A1 in Northumberland: Morpeth to Ellingham

Scheme Number: TR010059

6.38 Environmental Statement Addendum: Stabilisation Works for Change Request

**Environmental Statement Addendum:
Stabilisation Works for Change Request**

Temporary Works at the River Coquet

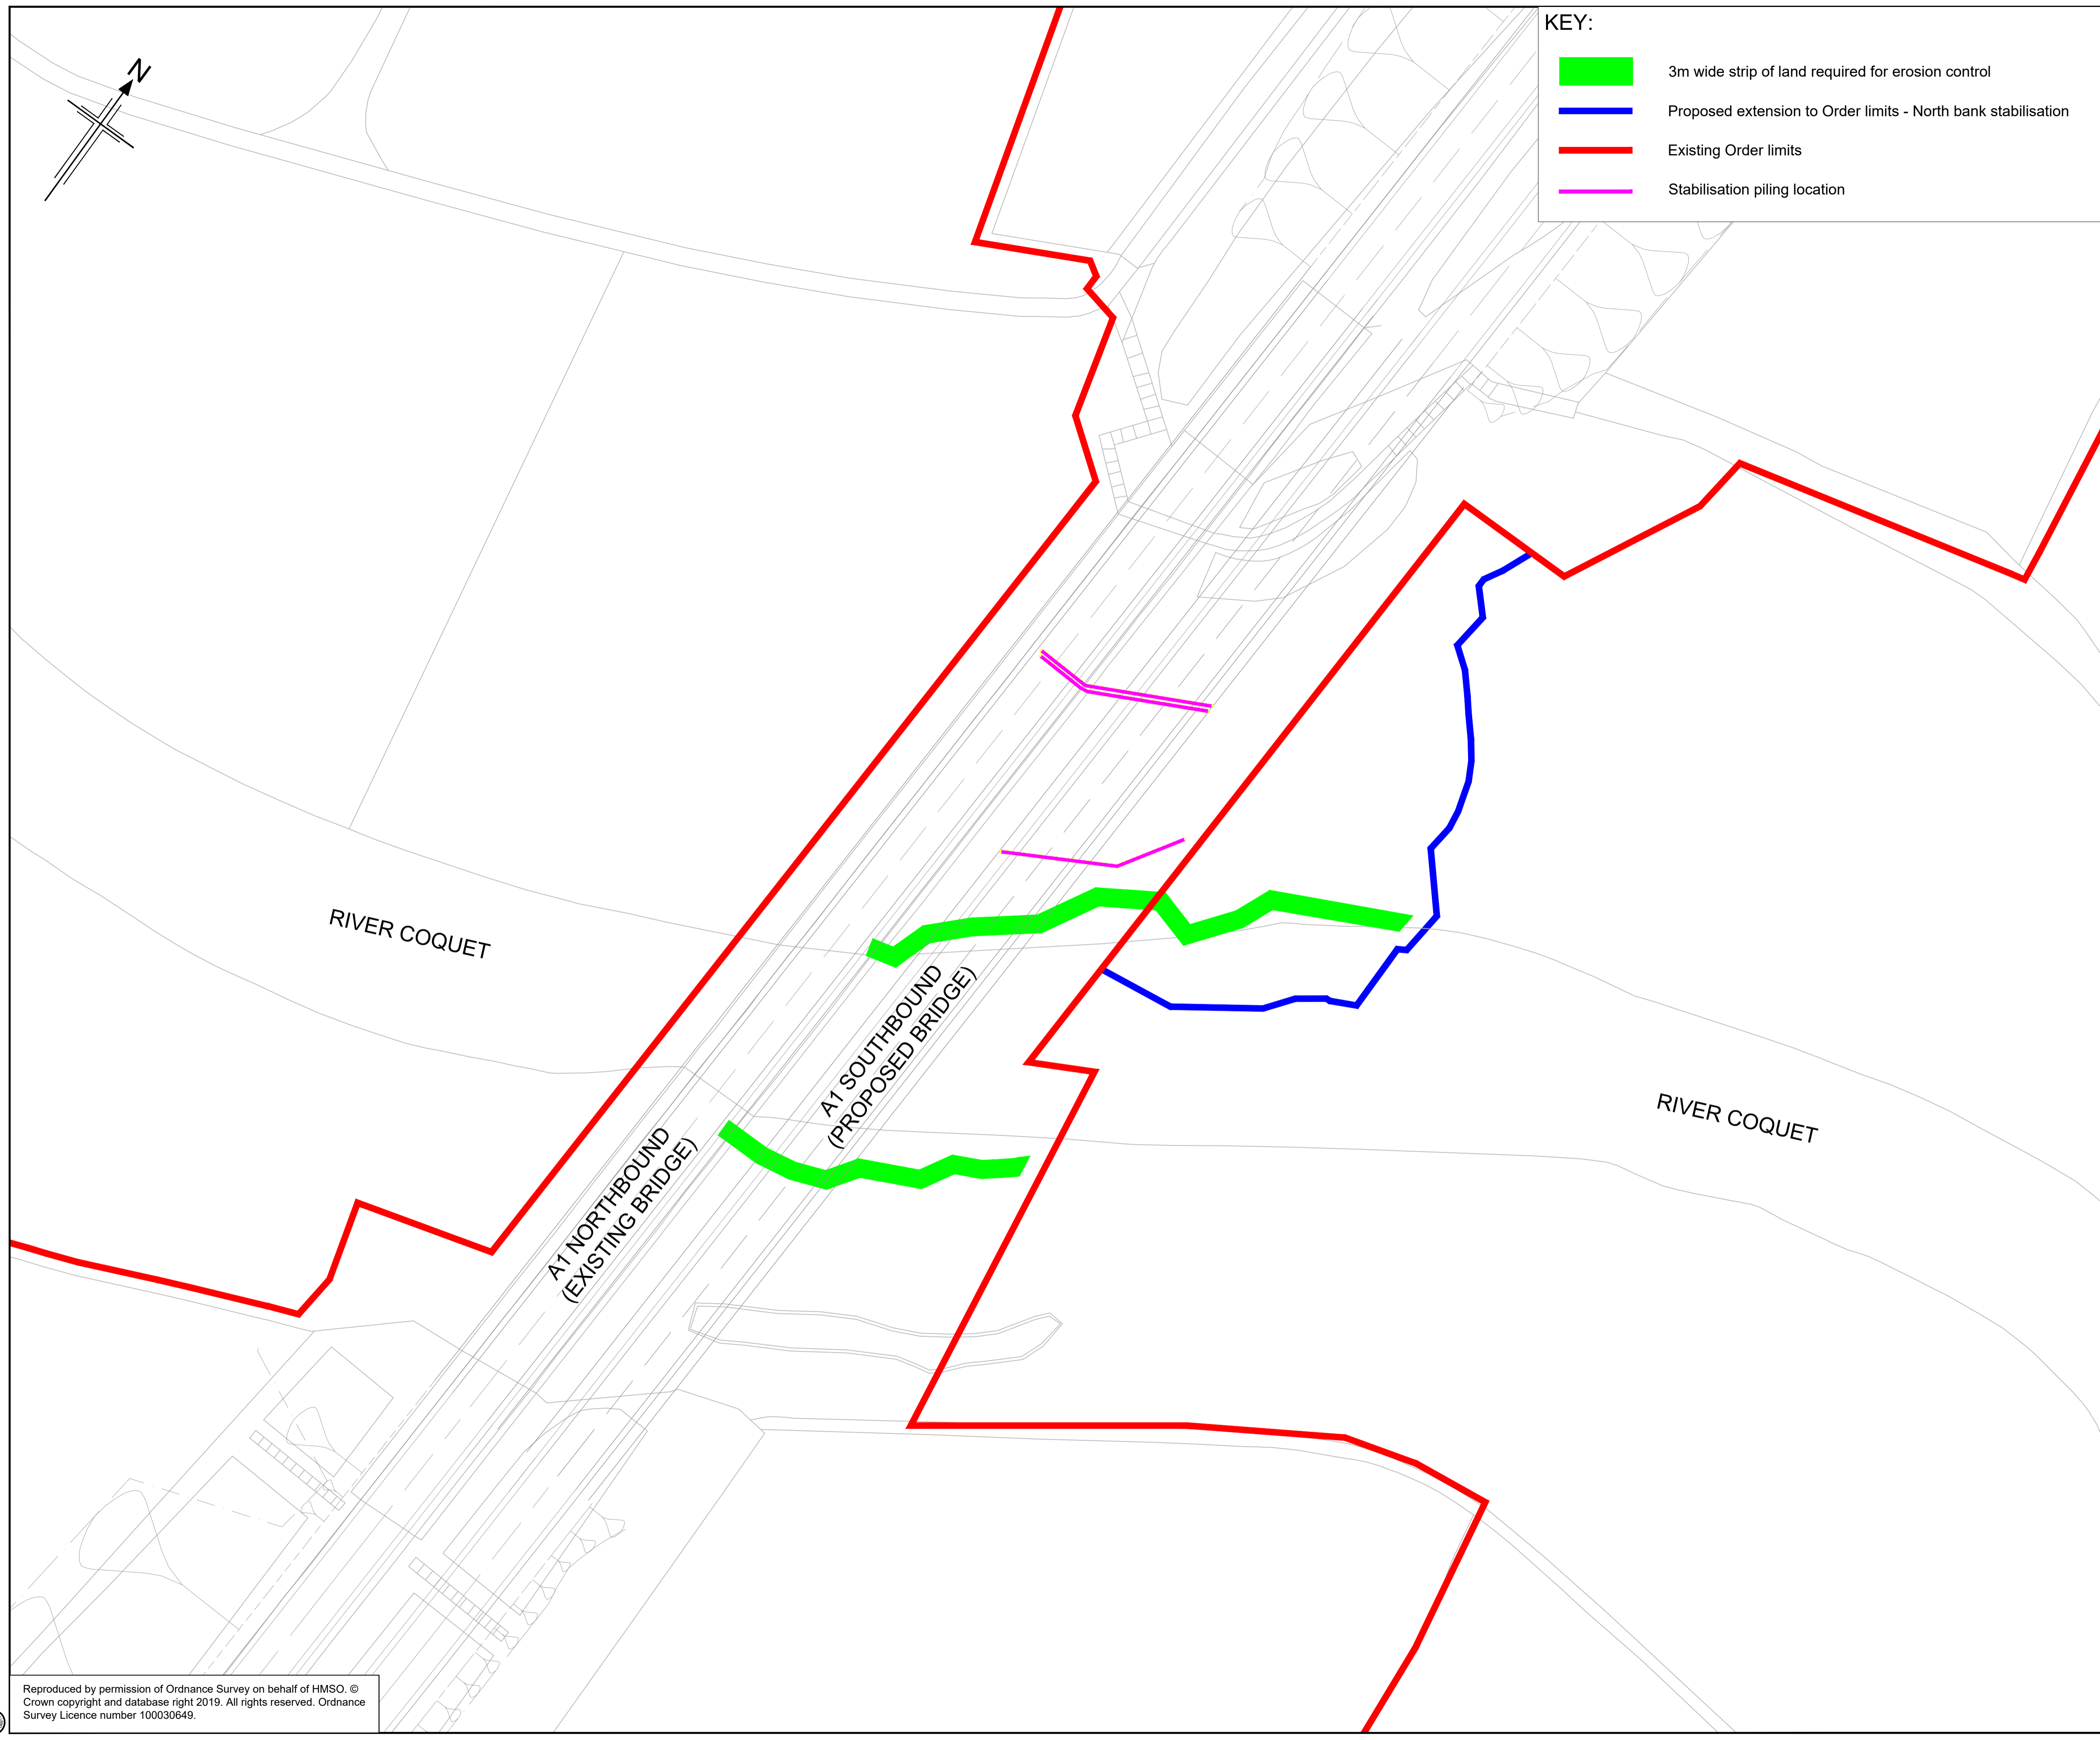
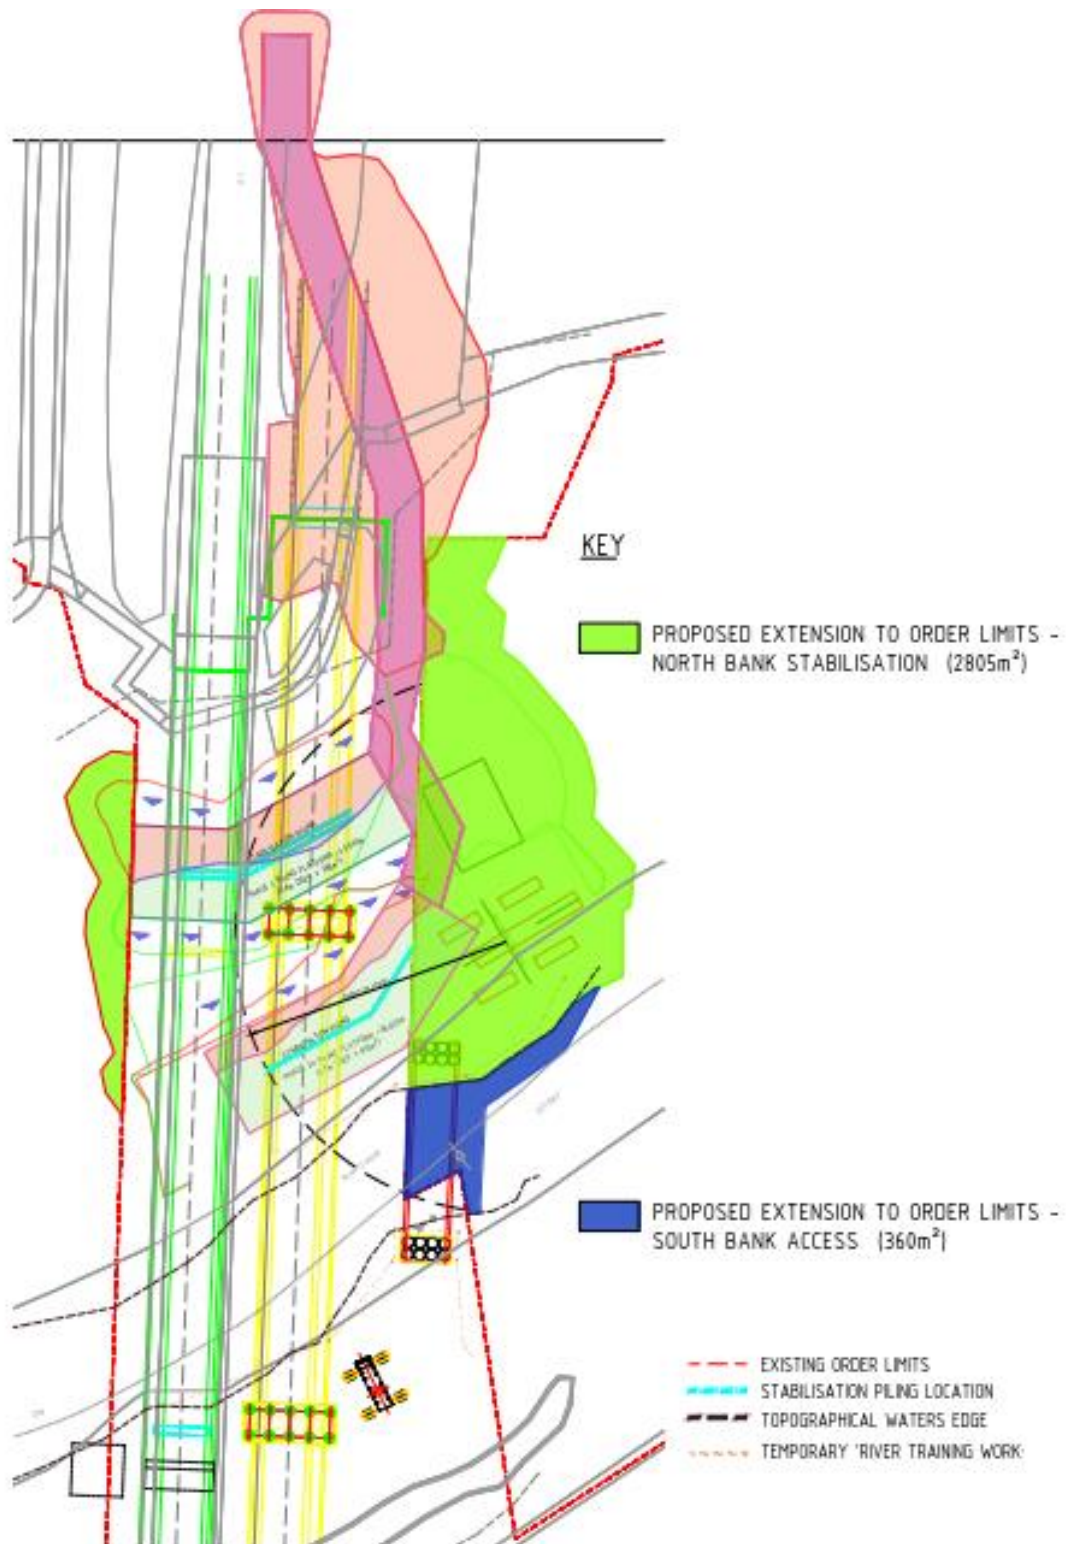
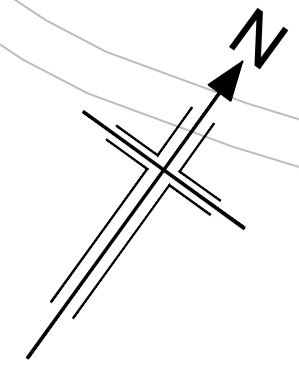
-  3m wide strip of land required for erosion control
-  Proposed extension to Order limits - North bank stabilisation
-  Existing Order limits
-  Stabilisation piling location
